ADDENDUM NO. 3

**2023 HEARTLAND HILLS AREA WEST WATER MAIN LOOP  
WATERLOO WATER WORKS,  
WATERLOO, IA**

DATE: May 4, 2023

Construction Plans for the 2023  
Heartland Hills West Area Water Main Loop  
Waterloo Water Works, Waterloo, Iowa  
Erosion Control Plan and Misc. Details

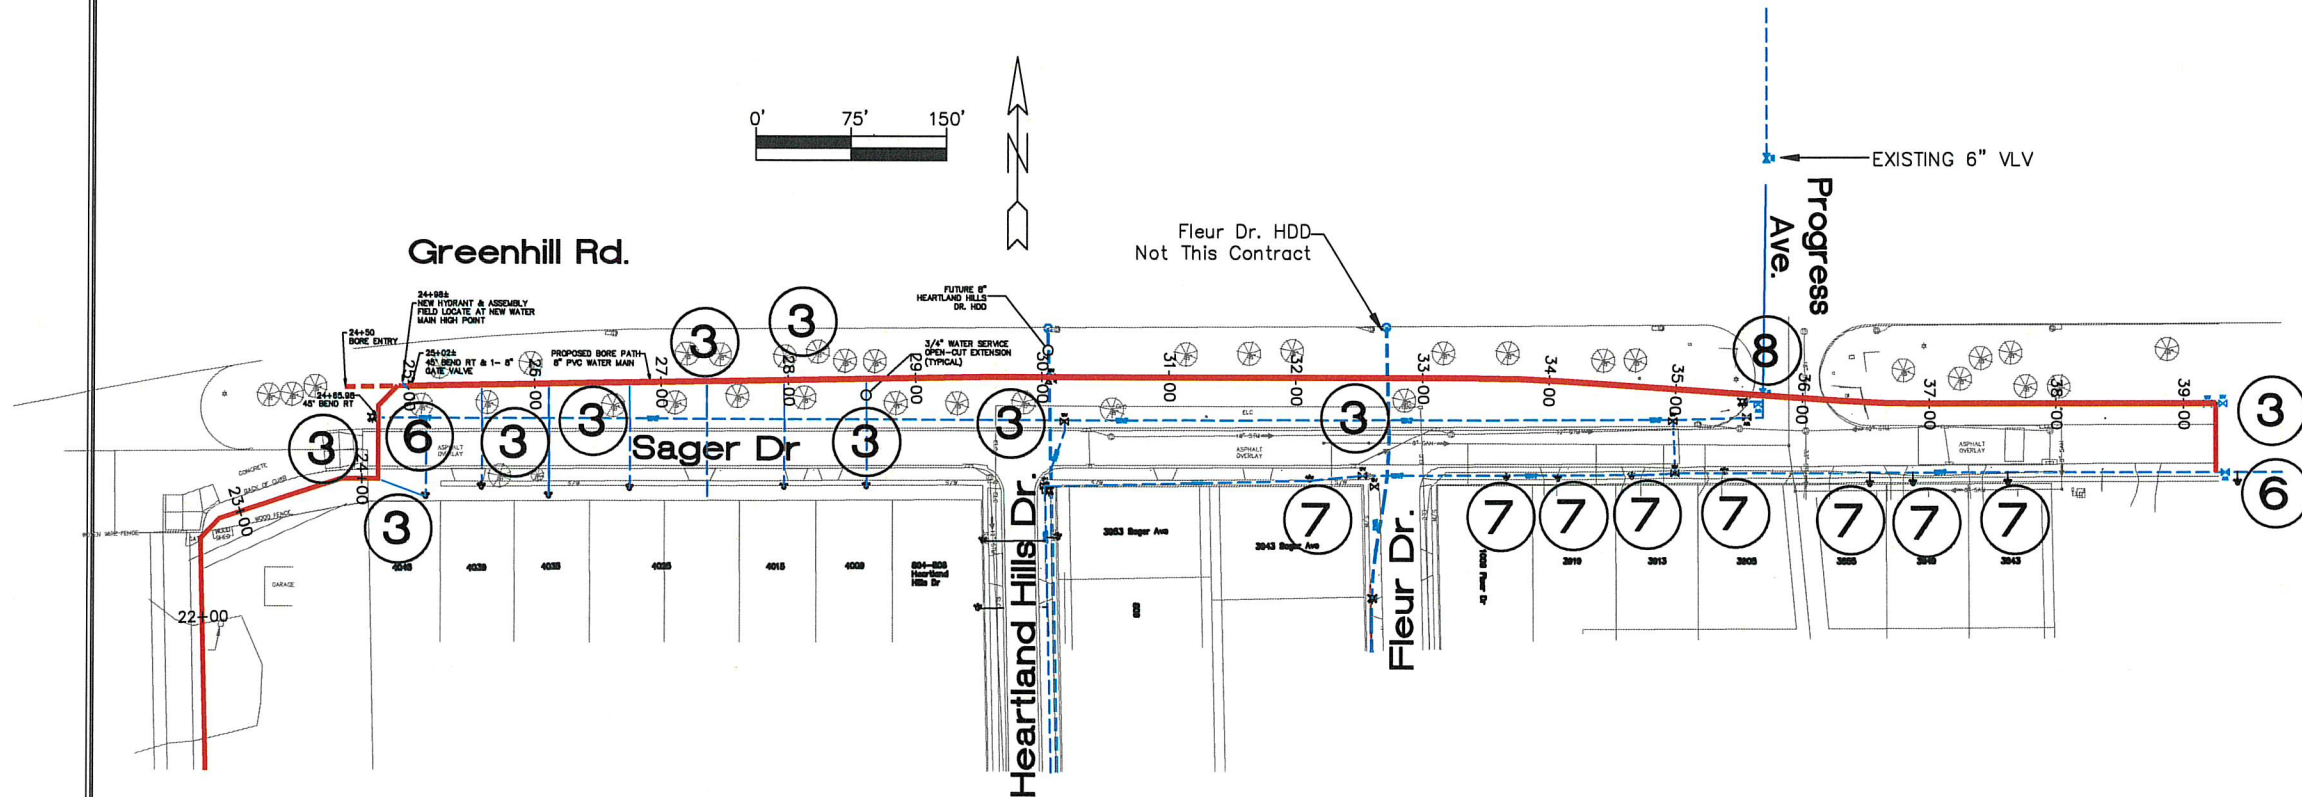
1. Add the attached Sheet 20 Erosion Control Plan and Misc. Details to the Construction Plans and add it to the Table of Contents listing of Sheets on Sheet 1 of the Construction Plans and page 1 of 5 of the General Special Provisions in the Contract Specifications.
2. Add Bid Item 007. Topsoil, Furnish, Haul and Place, 4" Rolled Thickness to Sheet 3 of the Construction Plans and to Page 1 of 5 of the Form of Bid or Proposal in the Contract Specifications. An updated Form of Bid or Proposal is attached herewith for Bidders to use for bidding.
3. Add the following Bid Reference Note for Bid Item 007. Topsoil, Furnish, Haul and Place, 4" Rolled Thickness, to Sheet 3 of the Construction Plans:
